TB1129

**LuK Part Nr. 233 0045 11 - TGU6 330/310mm**

**Lindner\*\***

**New design / Neues Design / Nouvelle conception / Nuevo diseño / Nuovo disegno**

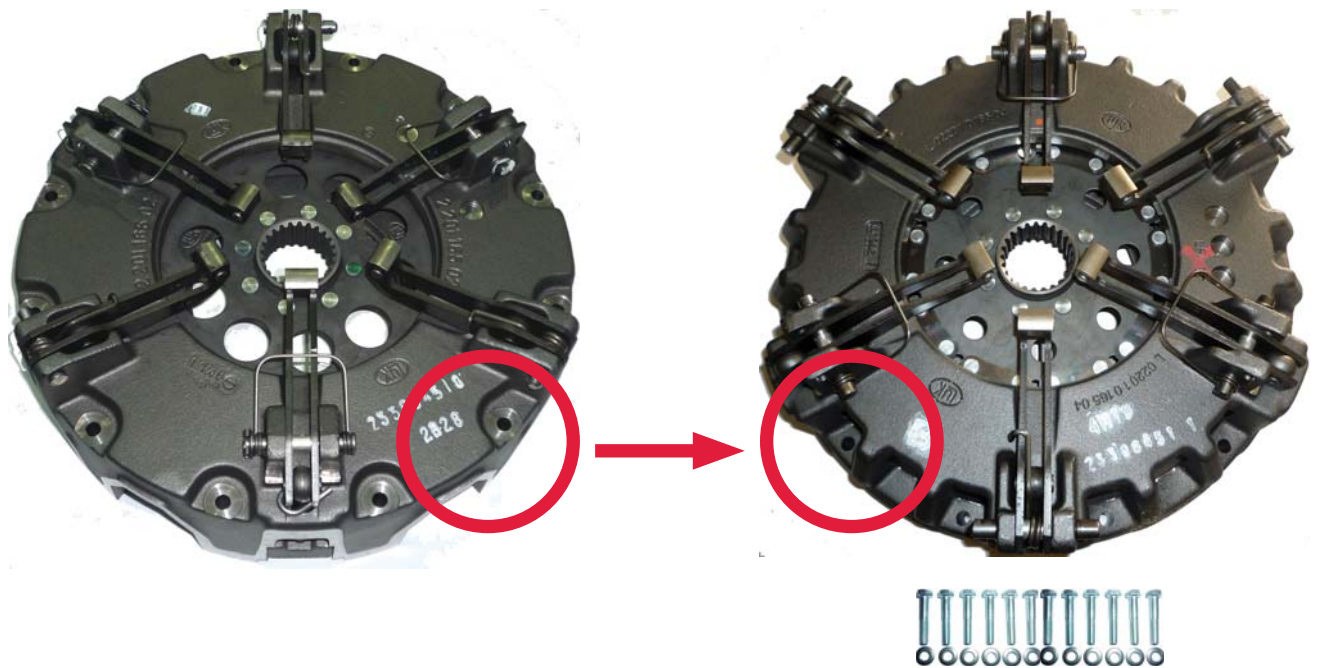
This new design utilises the latest clutch technology, using a vented housing for improved cooling and heat dispersal.

**Fully interchangeable with existing clutches with no modifications required to vehicle or flywheel.  
A new fixation bolt set 12 x M8 x 1.25 x 65mm is supplied with new designs to accommodate the lower housing.**
